D3034-1 BEARPAW △

D3034-3 BEARPAW △

2020 FEB 19
ECN 2020-520

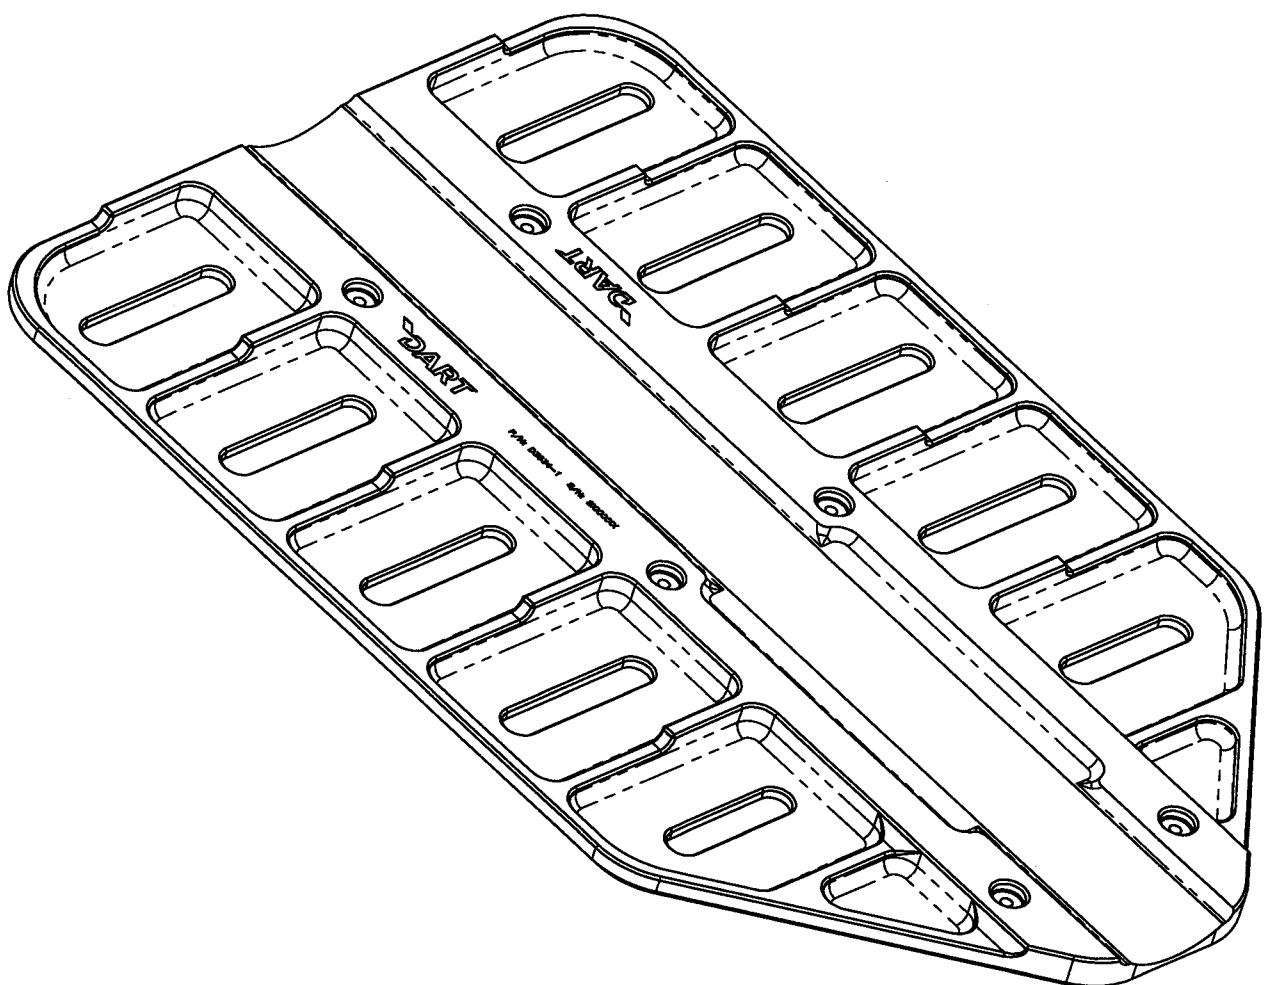
REV.	DESCRIPTION		BY	DATE
D	ADDED C'BORE TO -1/-3, ADD SECTION D-D & E-E SHEET 2, ADD DETAIL I SHEET 3, REVISE NOTE 1 FOR -1 & NOTE 6 FOR -1/-3, UPDATE DIMENSIONS & C'BORE NOTES SHEET 2 & 3	RF	20.01.30	
C	MATERIAL THICKNESS WAS 1.00 FOR D3034-3, NOW 1.250 (A8-3). MIDDLE SECTION OF D3034-3 BEARPAW MODIFIED (C2-3).	AP	12.10.10	
B	UPDATE FORMAT; ADD D3034-3; UPDATE NOTE 1 AND ADDED NOTES 8 & 9 (SHEETS 2 & 3)	AP	12.04.13	
A	NEW ISSUE	CP	01.06.21	
DESIGN	CP	DART AEROSPACE USA, INC. HILLSBORO, OR		
DRAWN	RF			
CHECKED	PM	DRAWING NO. D3034		
MFG. APPR.	RQ	REV. D SHEET 1 OF 3		
APPROVED	VS	TITLE BEARPAW		
DE APPR.	DS	SCALE NTS		
COPYRIGHT © 2001 BY DART AEROSPACE USA, INC. THIS DOCUMENT IS PRIVATE AND CONFIDENTIAL AND IS SUPPLIED ON THE EXPRESS CONDITION THAT IT IS NOT TO BE USED FOR ANY PURPOSE OR COPIED OR COMMUNICATED TO ANY OTHER PERSON WITHOUT WRITTEN PERMISSION FROM DART AEROSPACE USA, INC.
